*Proceedings of the Madras Government, Public Works Department,
22nd August 1865.*

The Station, Barracks, and Hospitals of Bangalore.

ROBERT S. ELLIS, C.B.,

President, Sanitary Commission.

PLAN C
 SHEWING RELATIVE POSITION OF 66 COTS
 IN
 NEW RACECOURSE BARRACK BLOCK AT BANGALORE
 SUB DIVIDED INTO BARRACK ROOMS,
 AND
 THE PROPOSED MODE OF OCCUPATION OF ALL ROOMS.

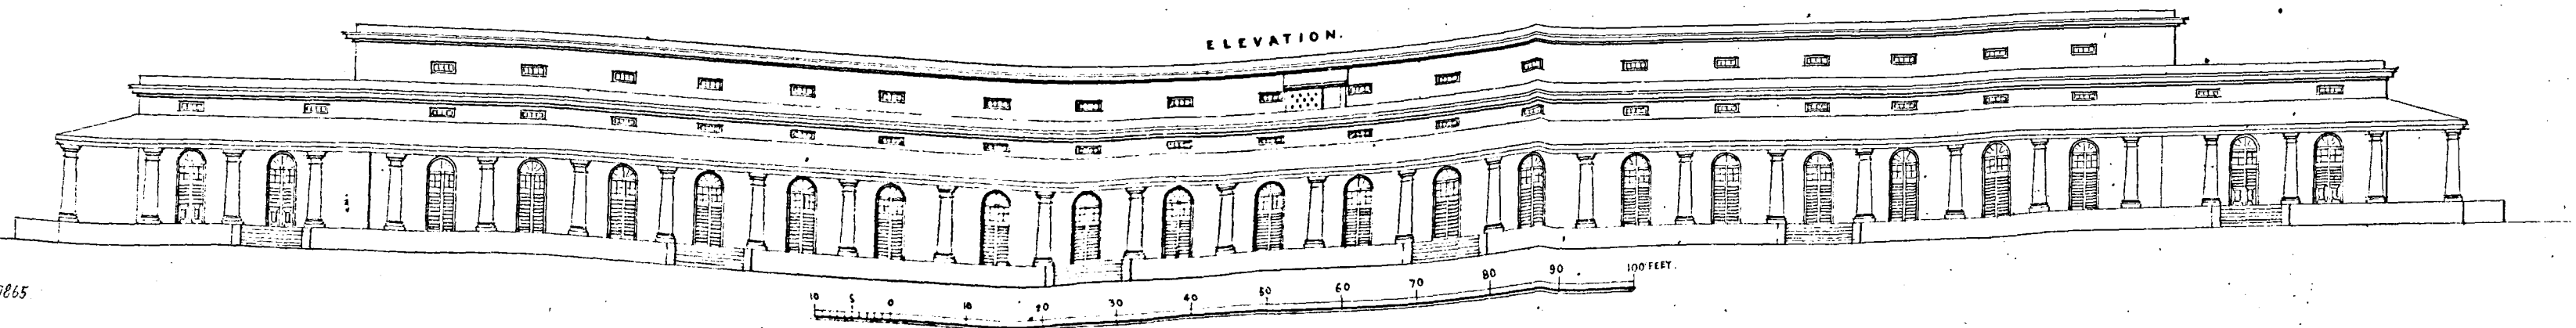
46. It was proposed, I was informed, to provide in the 8 Barrack blocks, for the accommodation of one Regiment of Cavalry and two Batteries of Artillery. But this cannot be done if the standard of space which has been authoritatively laid down is observed, or even according to the reduced standard which is, in the opinion of this Commission, sufficient in such a climate as Bangalore.

PLAN
OF A
WASH HOUSE FOR A BLOCK OF 7 MARRIED QUARTERS
FOR ARTILLERY
AT THE NEW DRAGOON BARRACKS ON THE RACE COURSE
AT BANGALORE

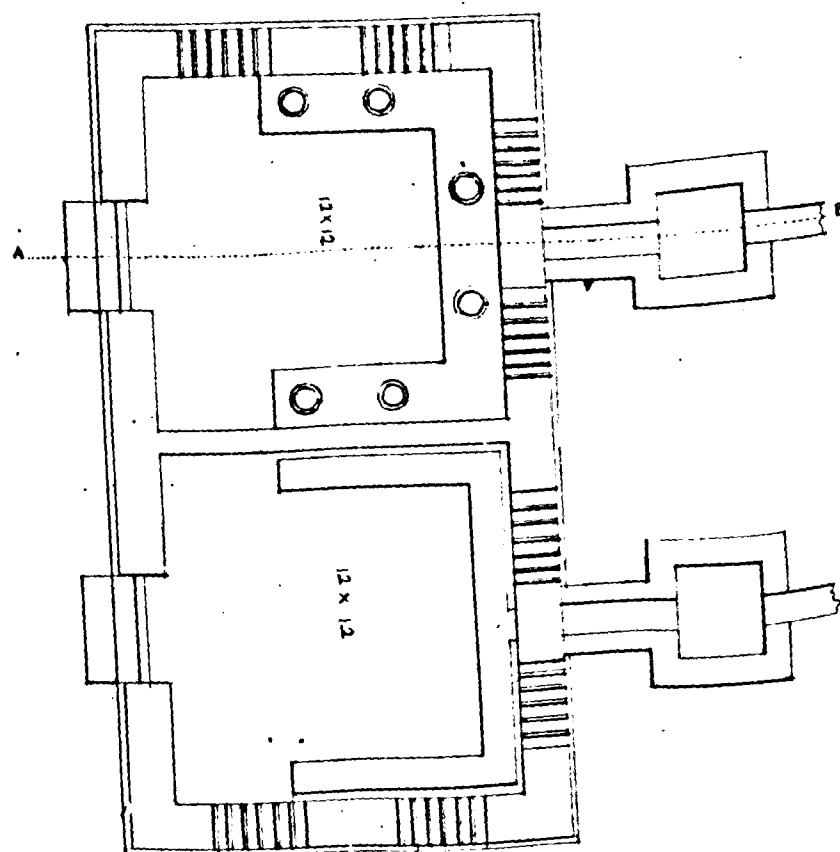
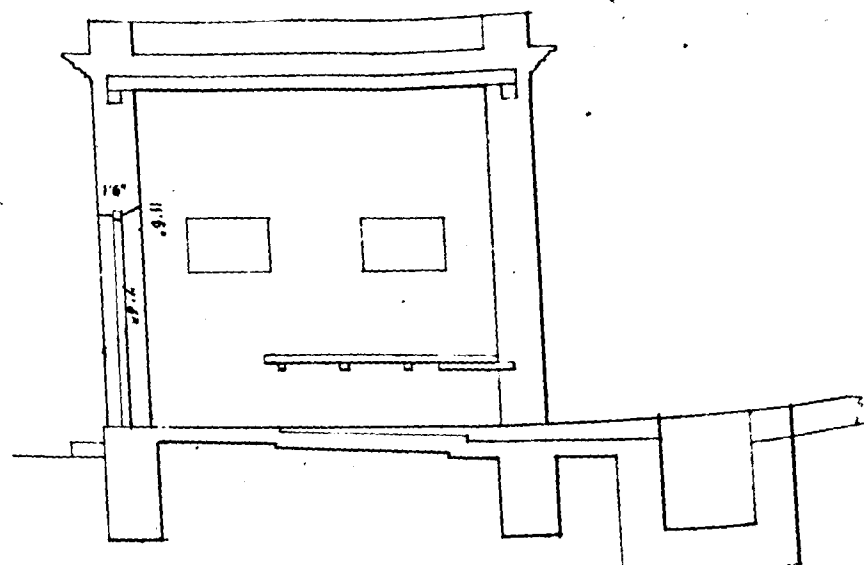
78. The plan for the Urinary and Wash-house attached to these quarters showed a combination of out-buildings that is highly undesirable. A Urinary to be inodorous must be strictly dry, and this it can never be if it is either flushed out by, or in close proximity to, a Wash-house.

Water with soap and organic matters in it is known to prove highly offensive if allowed to remain stagnant in chunam receptacles. The pit shown in the proposed plan might be entirely dispensed with and an open channel would effectually remove all water flowing from the Bath rooms. The V shaped granite channels so common in Bangalore would be well suited for this purpose.

PLAN
OF HOSPITAL OF 66TH REGIMENT OF FOOT AT BANGALORE
PROPOSED TO BE CONVERTED INTO A GARRISON HOSPITAL

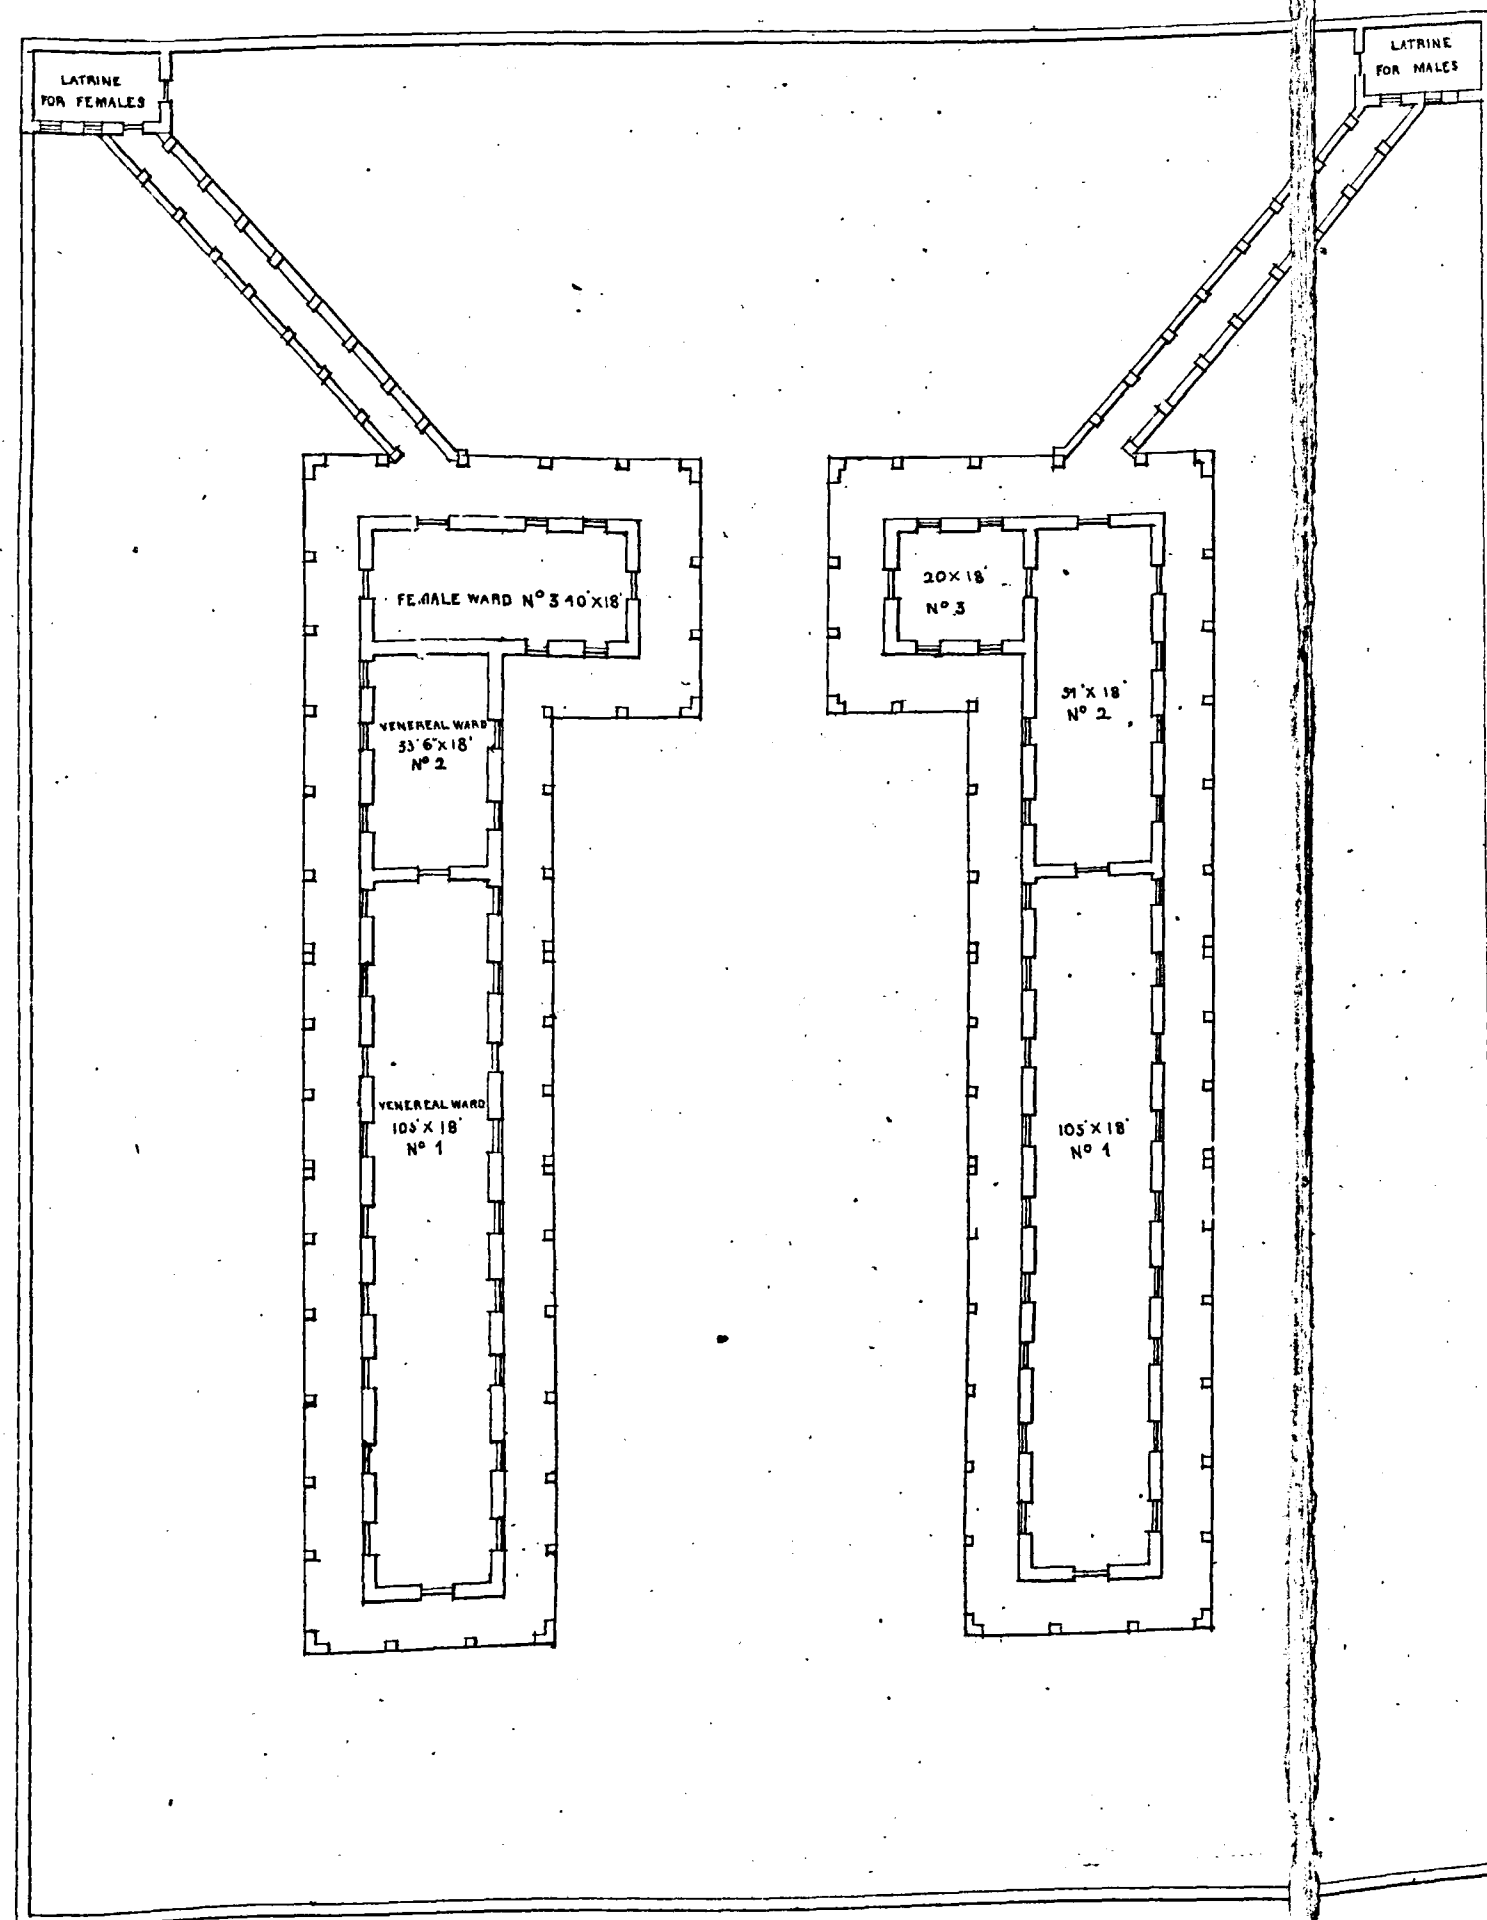
196. Some minor alterations may be required to fit it for this use, but they will be neither numerous nor expensive, for almost all that could be done, has been already affected to improve the condition of the Hospital. During the earlier part of the year 1863, there was much unhealthiness in the 66th Regiment. The conservancy of the Hospital was indifferent, and it was surrounded by a high wall which prevented thorough ventilation. This wall has been since removed and with a most beneficial effect.

PLAN
OF THE LIGHT CAVALRY BARRACKS,
FOR THE SARPENS AND MINERS AT
BANGALORE.
SHOWING PROPOSED ALTERATIONS AND IMPROVEMENTS.

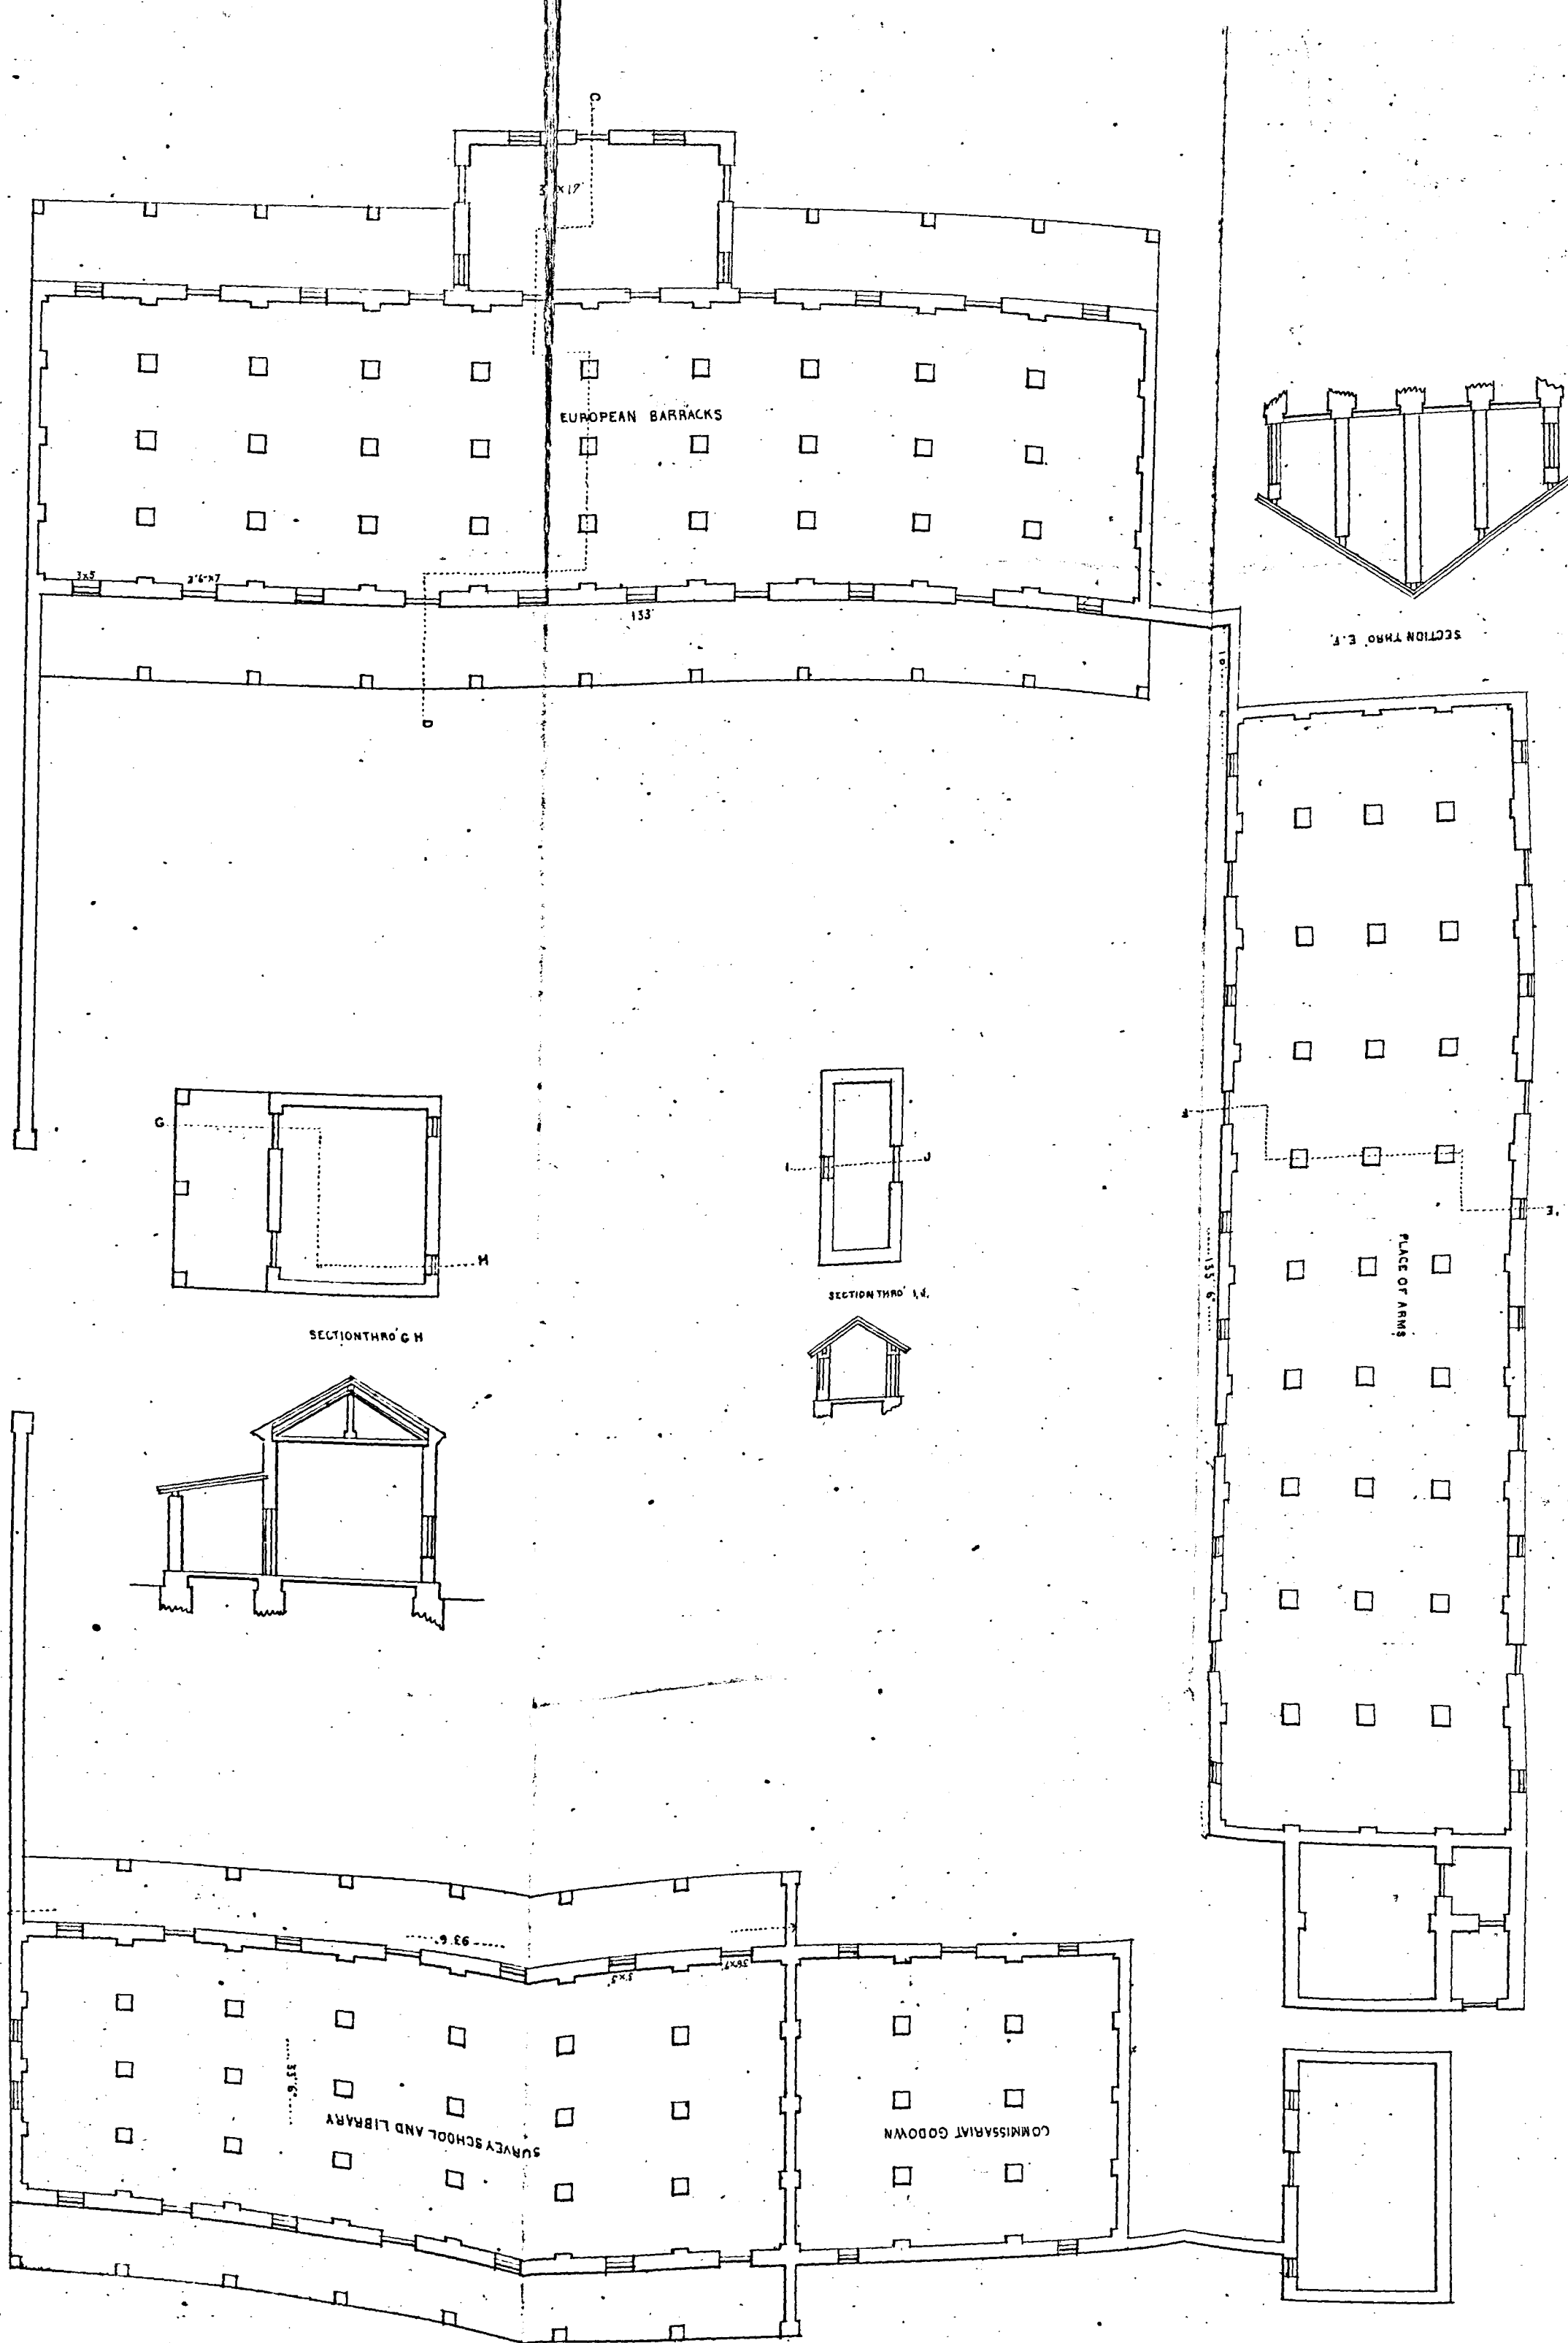
250. Of the buildings devoted to general purposes, the Barrack Block requires notice as it is intended to convert it into quarters for unmarried Europeans and School rooms. Of the subsidiary buildings used as places of Arms, Main Guard, &c., nothing need be said. They only require ordinary repairs and white-washing. The Guard room is on the standard plan and well ventilated. (Vide Plan.)

251. The Barrack block forms the rear of a quadrangle the left side of which it is proposed to convert into quarters for unmarried soldiers. To effect this the roof must be removed, the walls raised, the windows enlarged and the whole building improved as regards ventilation.

PUBLIC WORKS DEPARTMENT BLOCK PLAN.

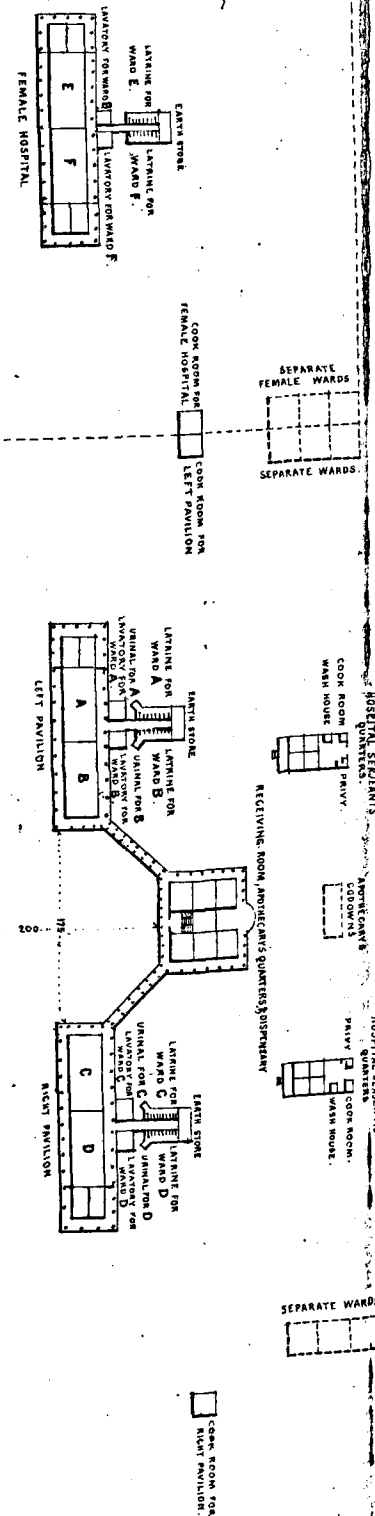
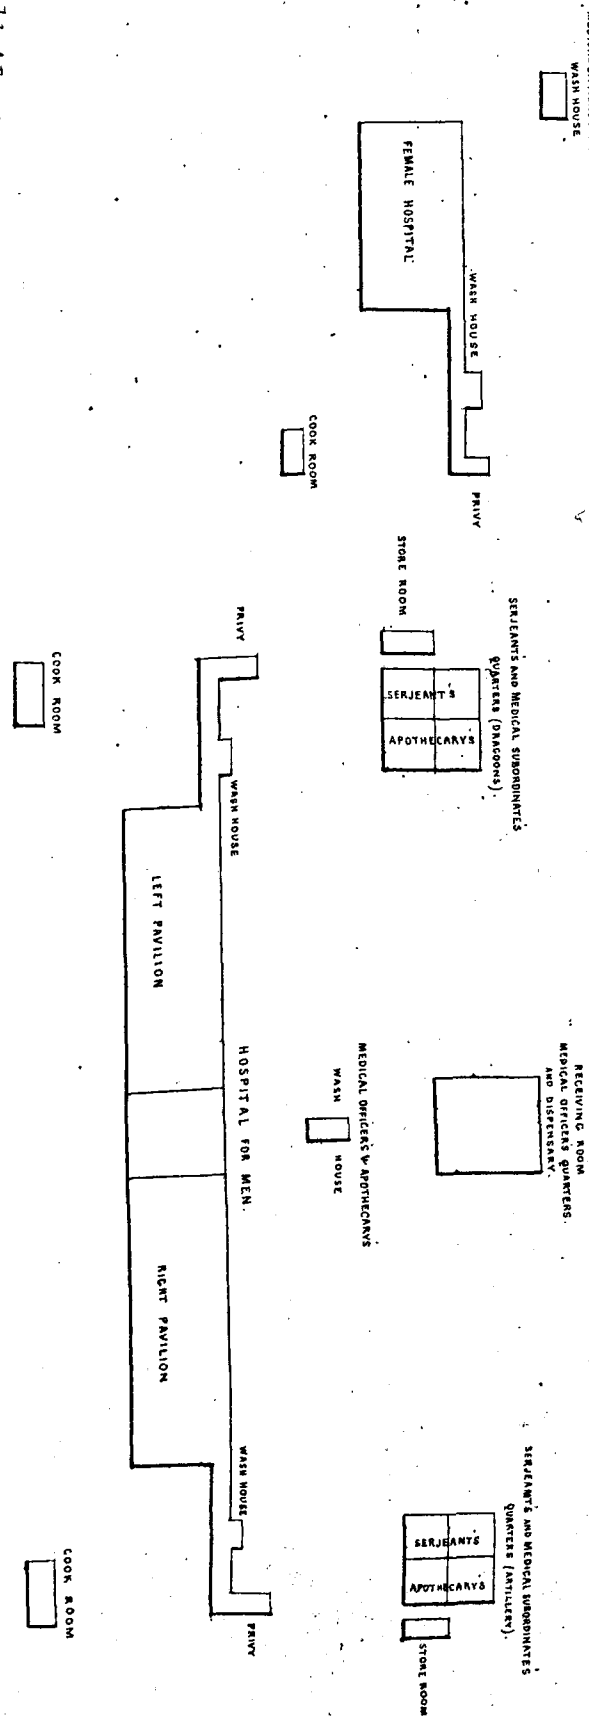
31. This should for Officers be done by a separate building to windward of the Hospital and not to lee ward as suggested in the Department Public Works plans.
